Attorney Docket No. 10123/00301 (03-008)

REMARKS

Appl. No. 10/630,885
Amdt. Dated Feb. 14, 2008
Reply to Office Action of Nov. 21, 2007
Annotated Sheet Showing Changes ± 1

FIG. 2

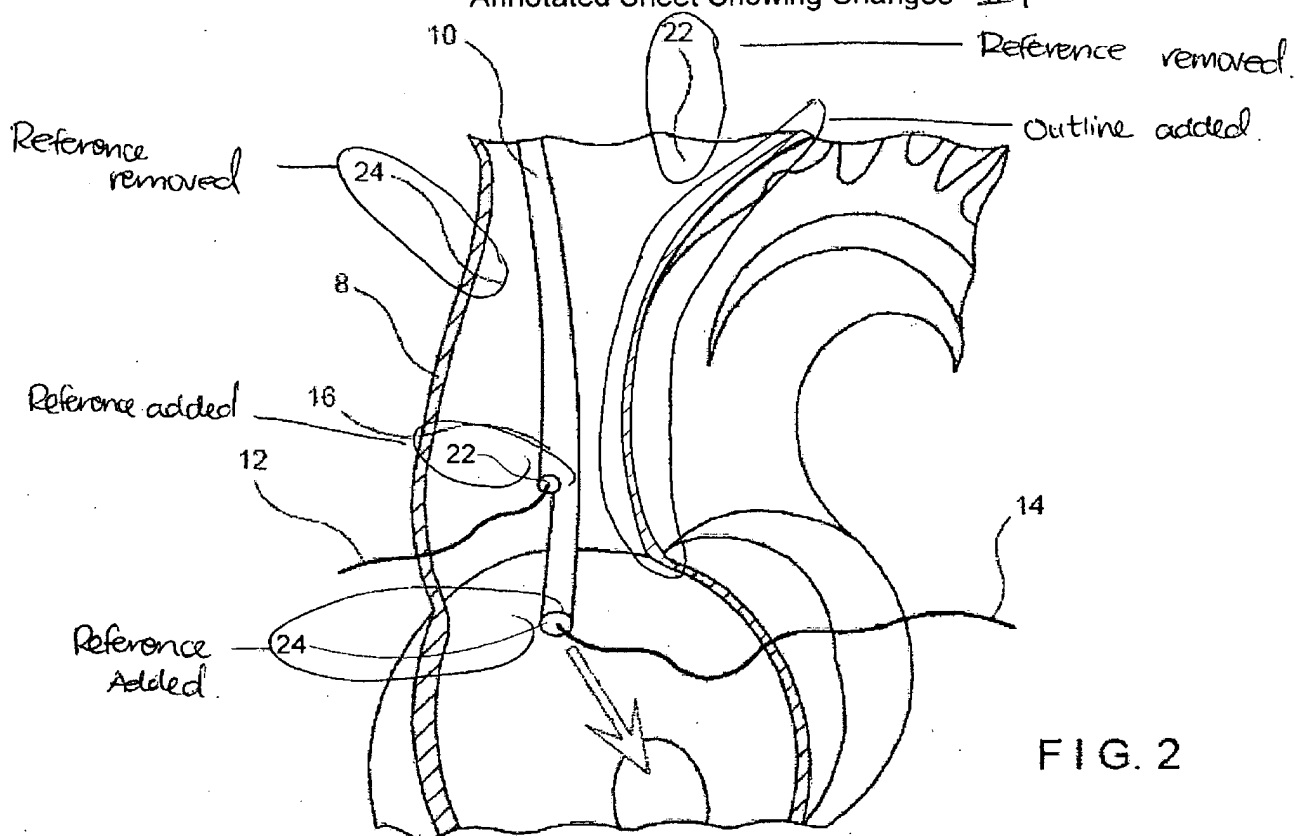
Figure 2 and 7 have been amended. Two sheets of Replacement Drawings are enclosed along with two Annotated Sheets.

Claims 1, 7, 8, 18, 19 and 26 have been amended. Claims 6 and 27 have been cancelled. Claims 20-22 have been withdrawn. Figures 2 and 7 have been amended. No new matter has been added. Thus, claims 1-5, 8-19 and 23-26 are now remain pending in the present application. It is submitted that, in view of the following remarks, all of the presently pending claims are in condition for allowance.

The drawings stand objected to under 37 CFR 1.83(a). In support of the rejection, the Examiner stated that the features of claim 6 are not shown in the drawings. (See 11/21/07 Office Action, p. 2). Claim 6 is directed to a "second lumen [of the first housing] ... wherein a second flexible disk extends across the second lumen." Figure 2 of the drawings has been amended to indicate the positions of the lumens 22 and 24. In light of this amendment, it is respectfully submitted that the drawings comply with all requirements and withdrawal of this objection is requested.
